# Tool & Product Update

## Nose Assemblies for 506 and 507 H.I.T.

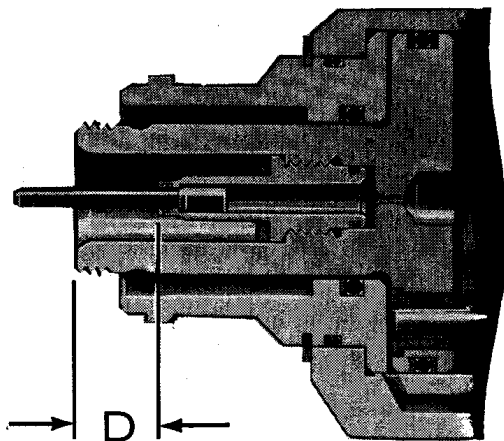
Nose Assemblies used on Models 506 and 507 Installation Tools are being shipped with two (jaw follower) caps. The shorter of the two caps is for use with older pistons and tools. The longer cap is for use with current pistons and tools. (The current pistons have a deeper counterbore in the end of the piston rod to accept the maximum length pintail at minimum grip without loss of tool stroke).

As shown in the table, there are three ways to determine which cap to use:

1. By tool serial number.
2. By Piston and O-ring Assembly number.
3. By measuring the "D" dimension.
